# **RESPONSE TO SIGNIFICANT PUBLIC COMMENTS ON THE PROPOSED CLEAN AIR MERCURY RULE**

**Proposed National Emission Standards for Hazardous Air Pollutants; and, in  
the Alternative, Proposed Standards of Performance for New and Existing  
Stationary Sources: Electric Utility Steam Generating Units  
(69 FR 4652; January 30, 2004)**

**Docket Number OAR-2002-0056**

**15 March 2005**

**Figure 1. Hg Emissions Projections from EPMM with Terminal Model Periods Starting in 2020 versus 2030**

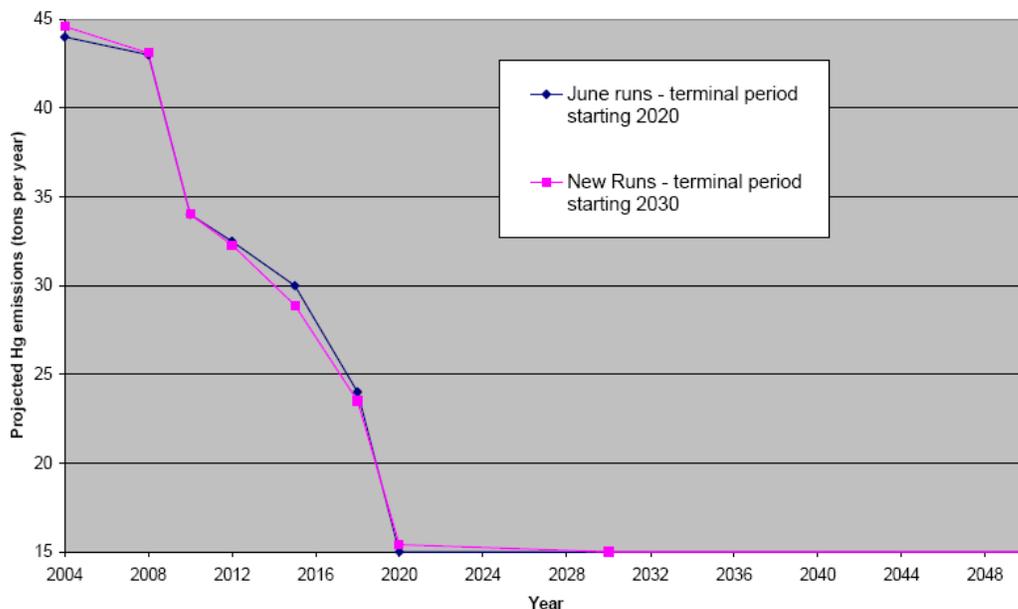
The commenter ran the extended-horizon version of EPMM for the same Hg cap-and-trade assumptions that were reported in the NODA Table 4 as with "improved ACI costs." Table 3 provides the emissions values from the original run when 2020 was the beginning of the terminal model period, and from the new run which differs only in that 2030 is now the beginning of the terminal model period. These emissions paths are illustrated in Figure 1. The

Figure 3. Impact on Glide Path of Setting Phase I Cap at Co-Benefits (For Two Alternative Co-benefits Cases)

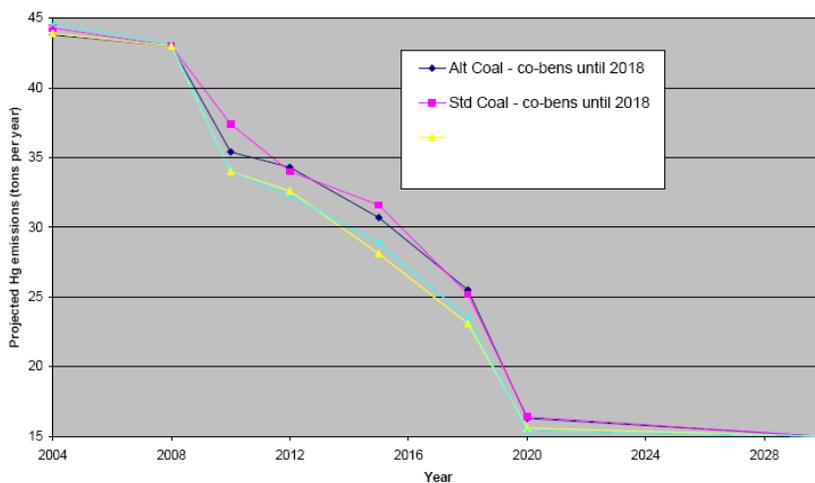
Tables 5 and 6 contrast the timing of ACI and FGD installations, respectively, for the case of Phase I being set by the co-benefits level, and the case of Phase I being set at a 34 ton cap. Figure 3 presents the glide paths of Hg emissions for both coal constraint cases. The

**Figure 4. Impact on Glide Path of Alternative Phase II Schedules in Combination with Phase I Set at Co-Benefits.**

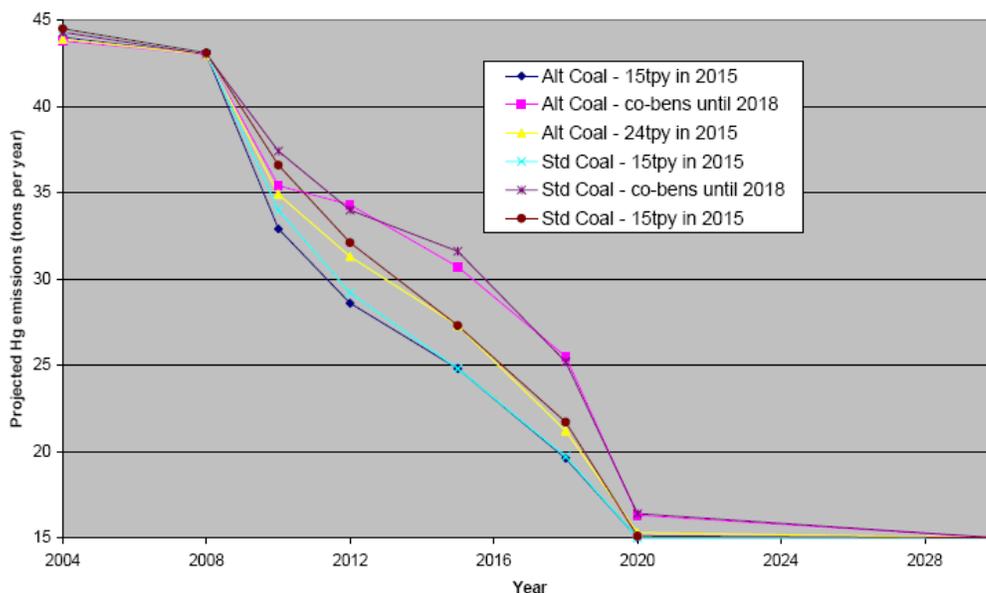
Figure 4 compares the glide path of each of these four scenarios to those in the previous section where the commenter set the cap at co-benefits in Phase I, but still allowing Phase II to enter force in 2018. Table 7 shows the associated quantities of ACI controls in each time step, which can be compared to the values in Table 5 as well. The early introduction of Phase II increases the rate of early action in Phase I, but still gets emissions to 15 tons by 2020. However, the commenter’s proposed alternative scenario, with an intermediate cap at 24 tons, provides a similar reduction by 2020, but with a slower rate of investments in the early years, when the costs of control are the most uncertain.

The commenter’s alternative cap proposal is very similar in nature to the simplistic sensitivity case that simply brings in a 15 ton cap by 2015. It has the same properties of requiring only cost-effective early action through 2015, yet bringing emissions to 15 tons promptly. The mechanism for accomplishing this effect was the same: by tightening the cap in 2015 in such a way that an allowance bank would not continue to accumulate at increasing rates for three additional years before the imposition of Phase II. The main differences of the

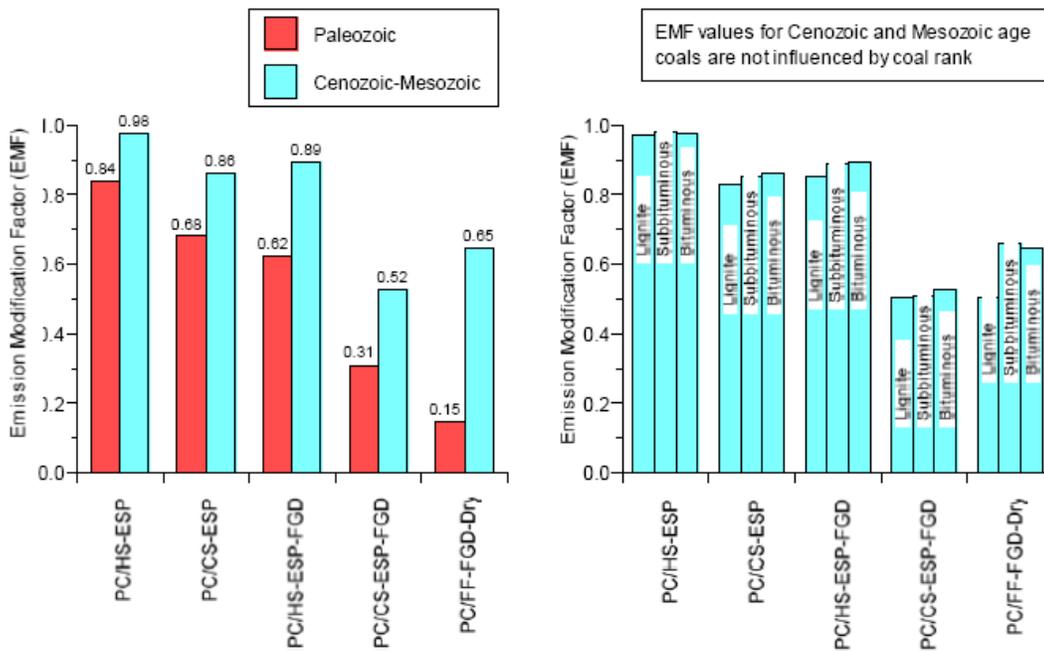
One commenter (OAR-2002-0056-5411) stated that their results indicated that the EMFs are not related to coal rank, but do vary with coal age. The consistent relationship between the

EMFs and the geologic age of coal, coupled with simple criteria that definitively establish the age of coal, provide a scientifically justified and practical basis to subcategorize coal for regulation of Hg emissions.

The commenter stated that commercial U.S. coal was formed during two, substantially different geologic ages, and can be broadly grouped as older Paleozoic coal, and younger Mesozoic/Cenozoic coal. The mutually exclusive geographic occurrence of Paleozoic coal and Mesozoic/Cenozoic coal is significant. Unlike coal rank, which varies locally, with ASTM standard vintage, and with assay precision, geologic age can be unambiguously determined based on coal origin location. Moreover, the origin location of coal shipments to units  $\geq 50$  MW is publicly reported; if regulation of units as small as 25 MW is required, determining the coal origin location is clearly less burdensome than representative sampling for coal rank assays. Finally, a precise coal origin location is not required to establish geologic age. Indeed, the “state-of-origin” reported on FERC form 423 is sufficient to establish geologic age for current coal production.
